**Beatrice Offshore Windfarm and Offshore Transmission Works Application for Marine Licenses and Section 36 and 36A Consents**

### Holding Objection by RSPB Scotland to Beatrice Offshore Windfarm and Offshore Transmission Works Application for Marine Licenses and Section 36 and 36A Consents

**Beatrice Offshore Windfarm Limited application for Marine Licenses & Section 36 Consent - Addendum**

**Moray Offshore Renewables Limited and Beatrice Offshore Wind Limited applications for Marine Licenses & Section 36 Consent – RSPB Scotland consultation response**

Figure 1. Kittiwake tracking data (RSPB confidential unpublished data)

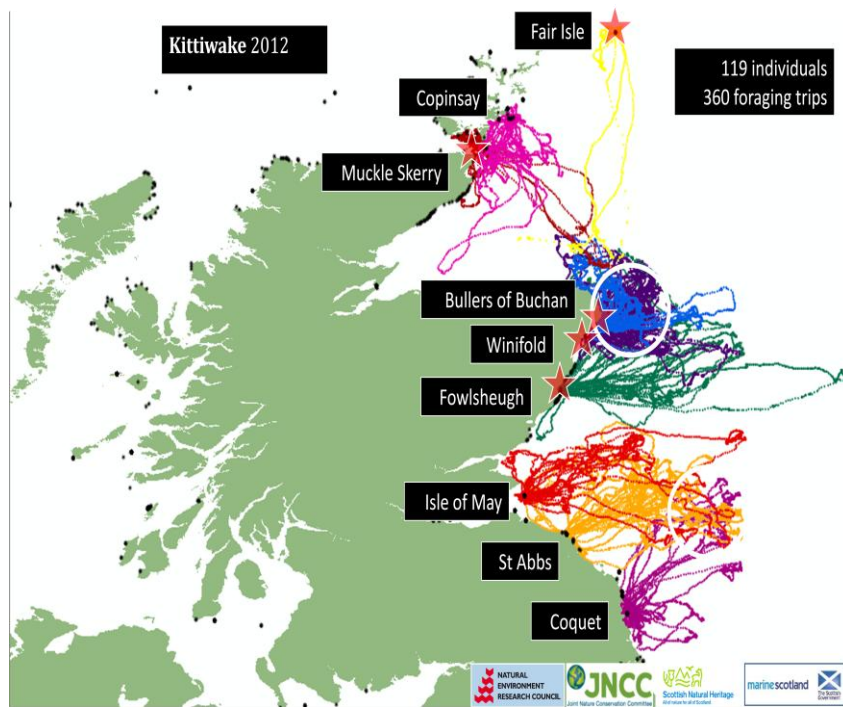
With regard to Kittiwake, (Figure 1), there is a possibility that kittiwakes from Fair Isle, and perhaps mainland cliff colonies south of Moray, might use the area including the proposed offshore wind farm sites. Although none of our records coincide exactly with the windfarm sites, one Fair Isle record comes relatively close. These tracking data cannot be used to prove a negative, ie that birds do not use certain locations, but they do provide an indication of areas they definitely do use. It is therefore not possible to completely rule out potential effects on colonies other than the East Caithness Cliffs.
